## STAFF REPORT

**REFERENCE:** RM090876

**SUBJECT:** **SUSTAINABLE VENTURES LTD - REPORT REP10-05-12** - Report prepared for hearing of 12, 13 and 14 May 2010

**Figure 1: a representative cross section of the trenches**

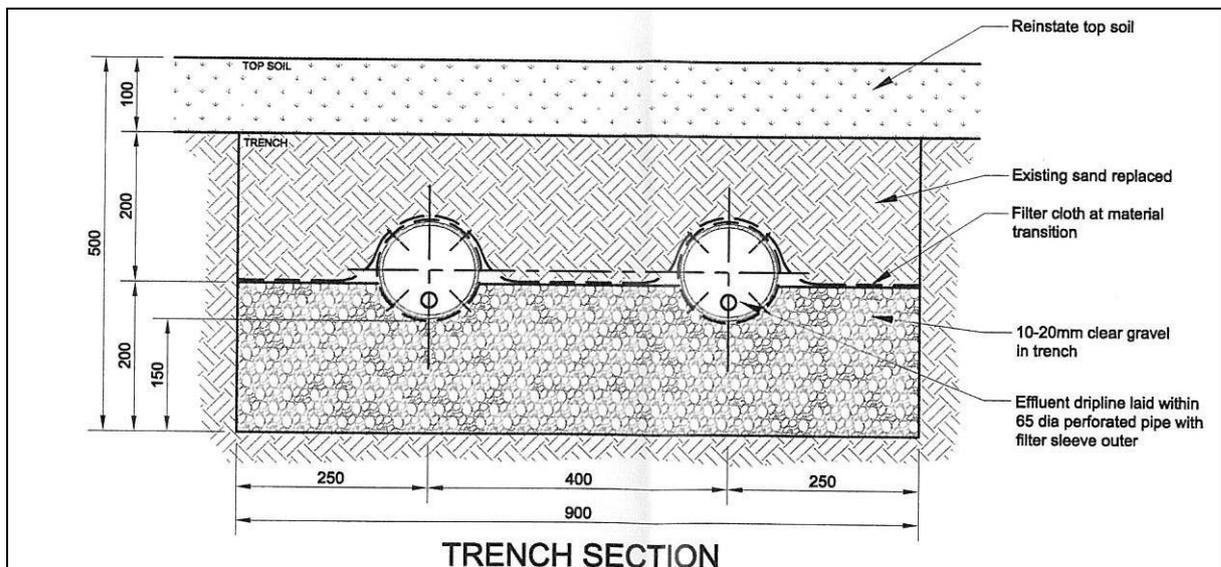
This design has advantages over both traditional trench design and dripper field design, as it provides for even distribution of effluent and also allows for the easy servicing and replacement of individual dripper lines, without the need for excavation. There is also the advantage that the trench system takes the weight of the surrounding land off the dripper lines and therefore allows for some concurrent landuse activities on the disposal field.

The proposed trench dispersal area is 292 m<sup>2</sup> consisting of 328 lineal metres of trenching. The applicant notes that the adopted arrangement is subject to final design and that whilst the preferred distribution method noted in the report is dripline irrigation, the use of conventional low pressure pipe will also be considered. If dripline is used wastewater will be emitted at 1.6 litres per hour from drippers spaced 0.5 metres apart. If low pressure pipe is used wastewater would be emitted from 3 mm holes drilled every metre.

It is proposed to locate the land application area on the seaward side of the units. The distance from the trench to the toe of the rock wall is between 14 to 20 metres. Any erosion of the coastline will reduce this setback but is discussed in detail in the report for consent RM090878. The erosion figures estimated by Jim Dahm (see RM090878) may result in the land application area being in the sea. The wastewater application makes the assumption that the site will be protected from coastal erosion.

**Figure 1: Enterococci values measured at Pakawau Beach (source: Tasman District Council)**

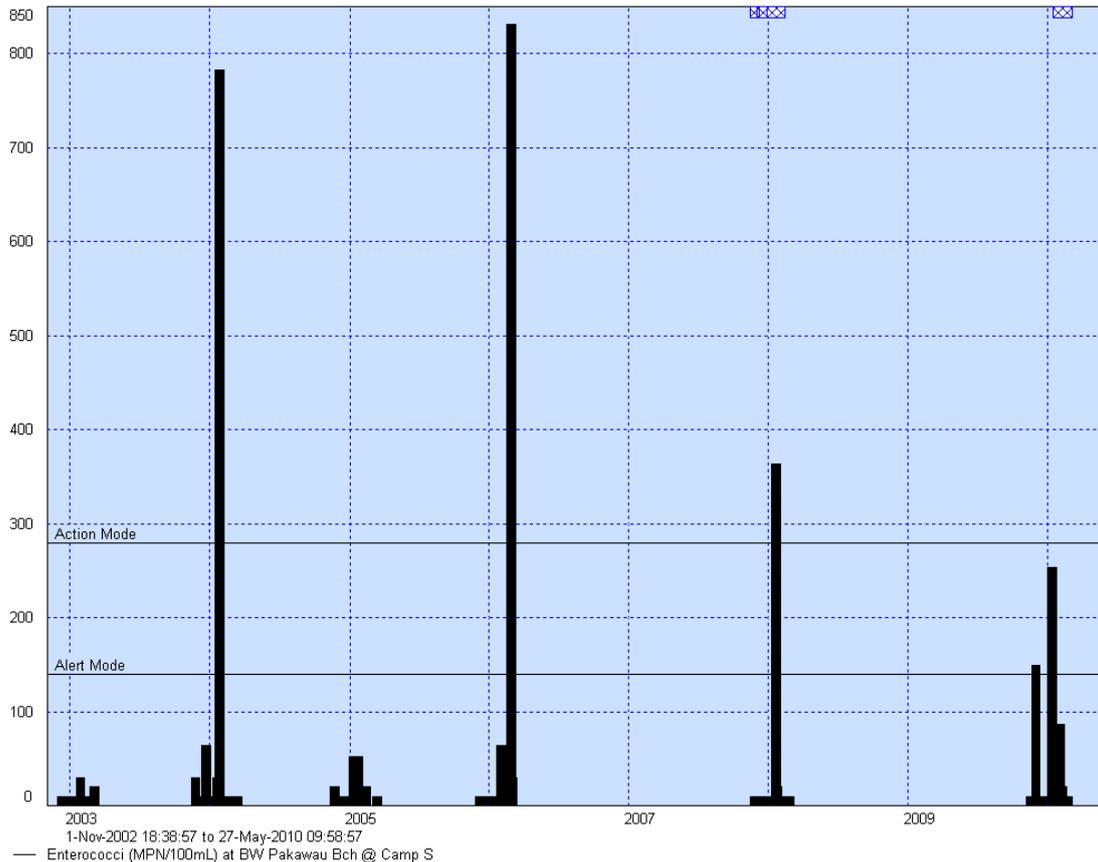
However, it is noted that Council test results (Figure 1) show that there is already some faecal contamination in the bathing beach survey (taken in about 0.5 metres of water). Possible sources of this contamination include on-site wastewater systems

servicing baches in the area, and dairy effluent discharges. With regard to the baches, many in this area are of considerable age and may have wastewater systems that are of a very low technology and discharge wastewater that is very poor in quality. This view is to some extent a supposition and would need to be confirmed by assessment of wastewater systems in the area. Building consent information would provide useful information on the age and type of wastewater systems servicing baches, but it is considered unlikely that many of those systems treat and discharge wastewater to the quality as high as that proposed by the applicant.

Plan A: Sustainable Ventures Ltd., Location of Wastewater Disposal Areas

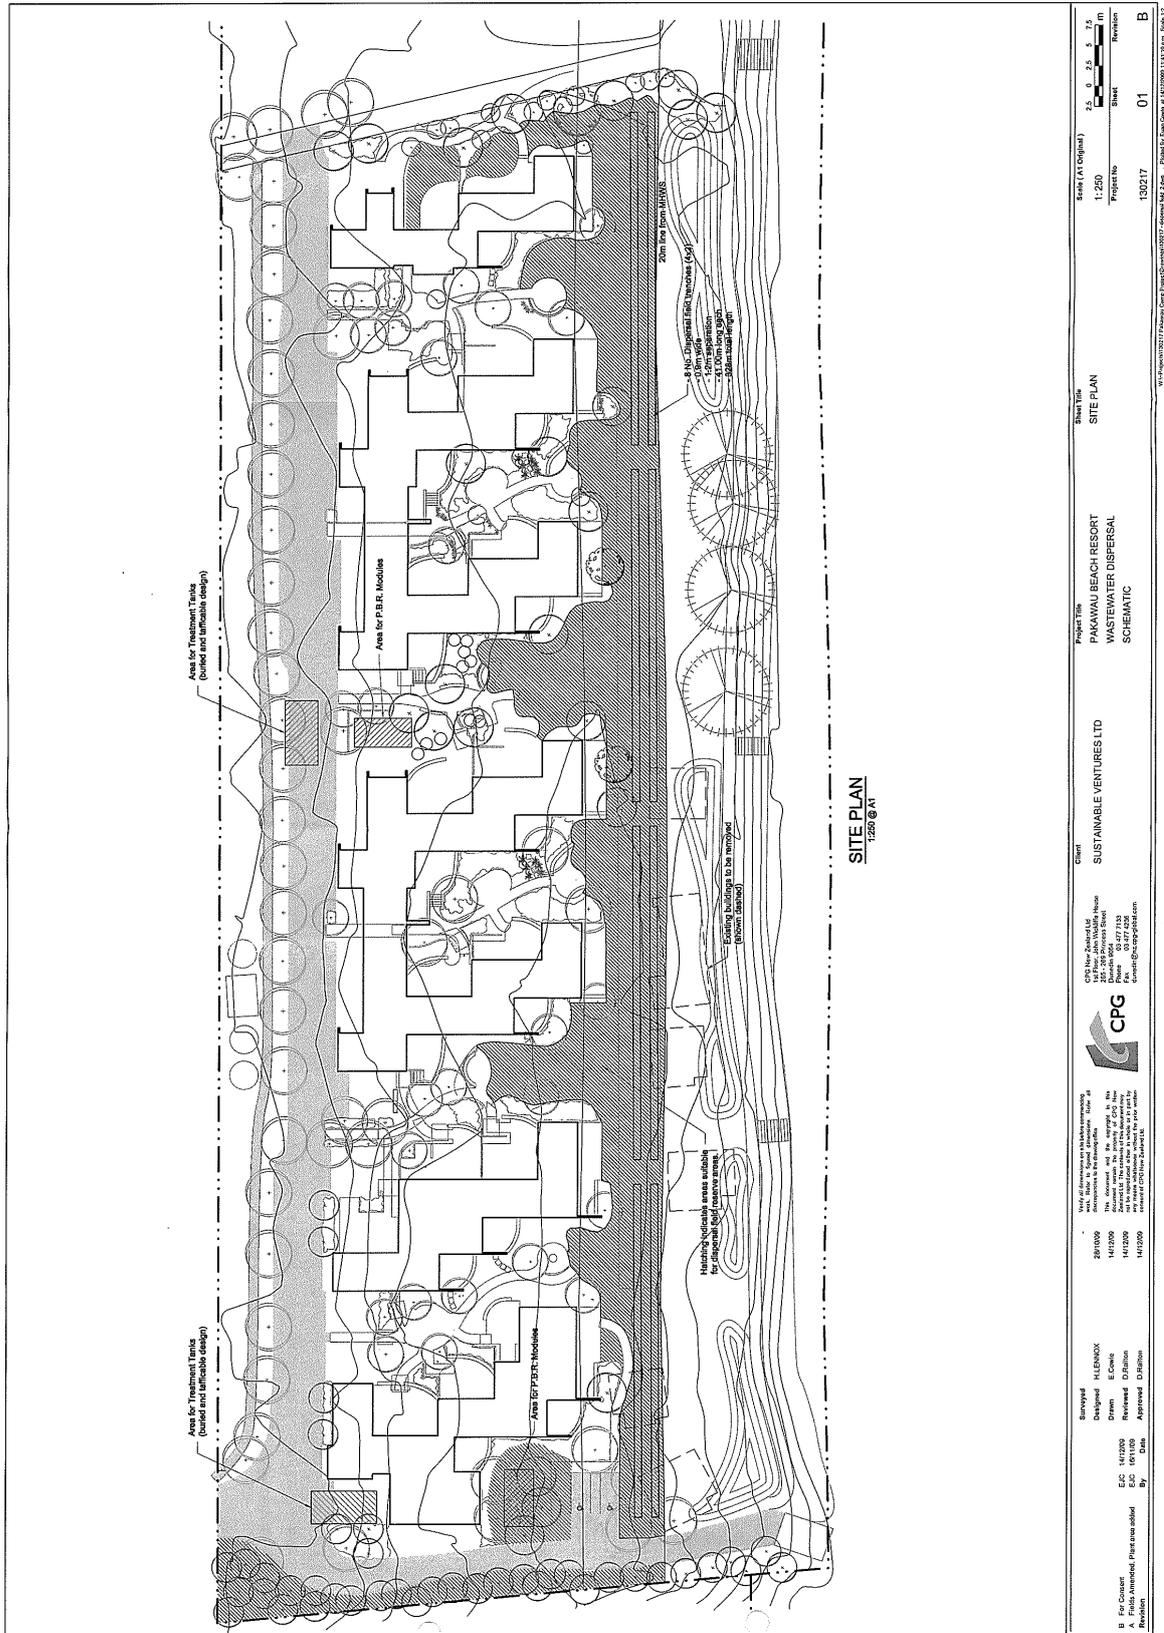
7. Trenches shall be laid level.
8. The land application area shall be located as shown in Plan A, in Appendix 1 below. If the area shown of Plan A does not meet the separation in Condition 6 a new plan shall be submitted to Council's Co-ordinator Compliance Monitoring for approval and this shall supersede the attached Plan A.
